GM SERVICE AND PARTS OPERATIONS
DCS1647
URGENT DISTRIBUTE IMMEDIATELY

Subject: 06077 F/CMVSS NonCompliance Recall
Air Brake Application Valve Assembly

Models: 2006 Chevrolet Kodiak 7500/8500, T-Series 7500/8500
2006 GMC TopKick 7500/8500, T-Series 7500/8500
2006 Isuzu HVR, FVR, FXR

F/CMVSS NONCOMPLIANCE RECALL

1850285

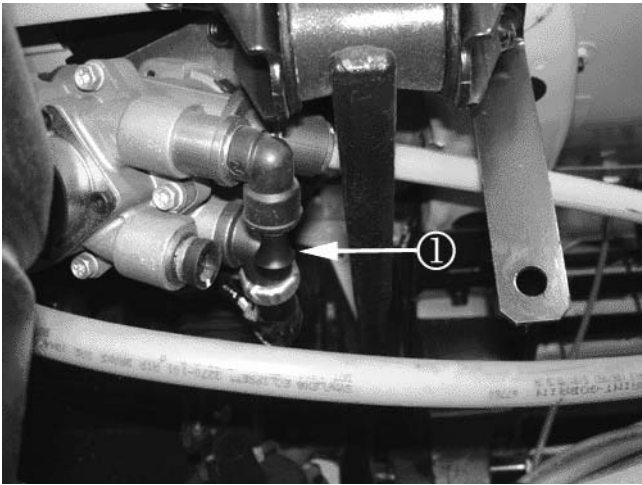
4. Cut and discard the air harness tie strap (1) at the formed steel bracket.
5. Cut and discard the two black harness bundle tape wraps (2) below the tie strap.

1850283

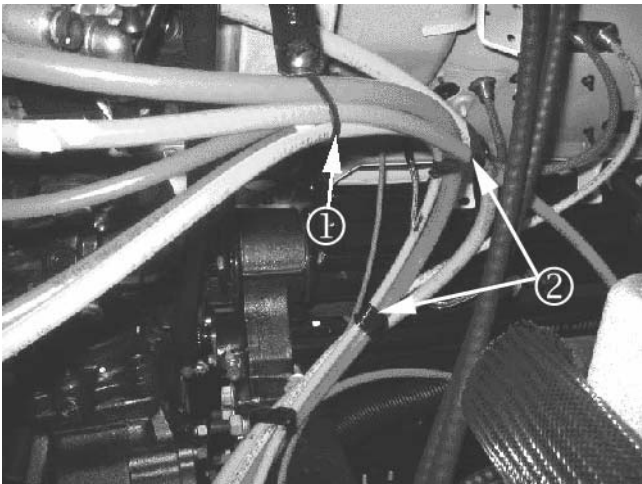
6. Disconnect the 9.5 mm (3/8 in) OD orange "KS" air supply tube (1) from the brake application valve.

1850282

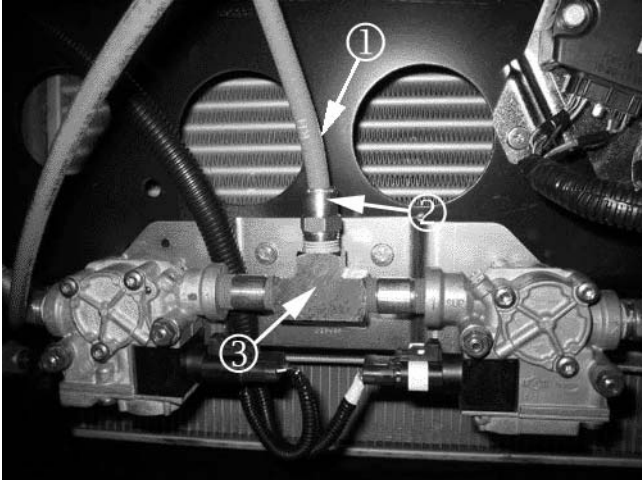
7. Install a "golf tee" sealing plug (1) in the vacant connector.
8. Extract the 9.5 mm (3/8 in) OD orange "KS" tube from the air supply harness.
9. Re-route the 9.5 mm (3/8 in) OD orange "KS" tube to the center of the front modulator valve assembly and shorten the "KS" tube by 178 mm (7 in).

1850278

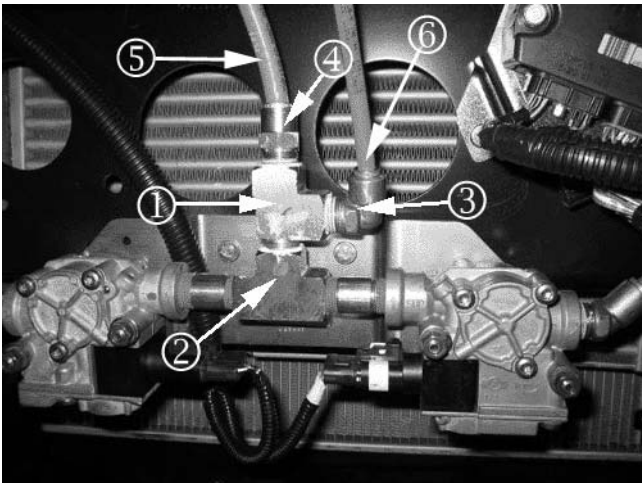
10. Bundle the air harness, minus the "KS" tube, and secure it with black tape or tie straps (2) in the same locations that the tape was cut.
11. Install a new tie strap (1) to secure the air supply harness to the formed steel bracket.

1850280

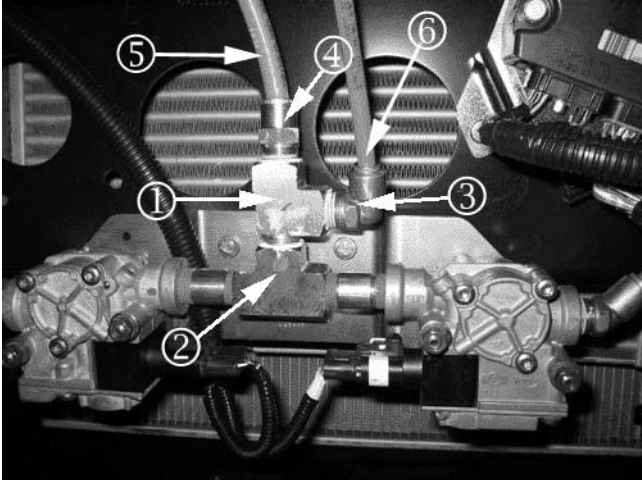
12. Disconnect the 13 mm (1/2 in) OD orange "KH" air supply tube (1) from the straight connector (2).
13. Remove the existing straight connector (2) from the top (female) connection of the existing tee fitting (3) in the center of the front modulator valve assembly. **DO NOT** discard the straight connector (2).

1850280

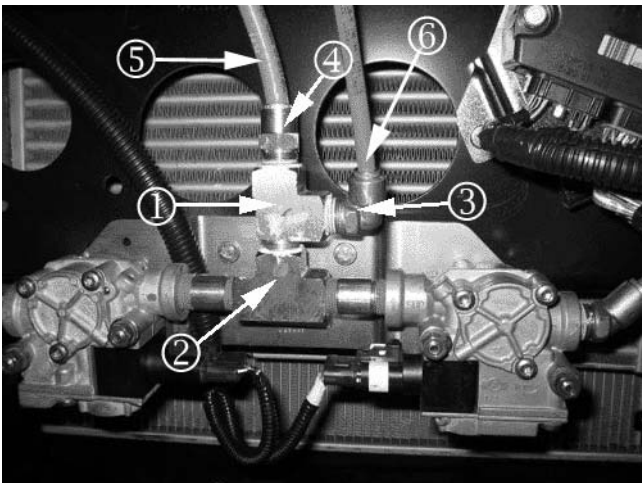
14. Apply Loctite 567 (or equivalent) thread sealant to the male threads of the tee fitting (1).

15. Install a new tee fitting (1) to the top (female) connection of the existing tee fitting (2) of the front valve modulator valve assembly.
16. Apply Loctite 567 (or equivalent) thread sealant to the male threads of the elbow (3).
17. Install the elbow (3) into the left hand side port of the new tee fitting (1).
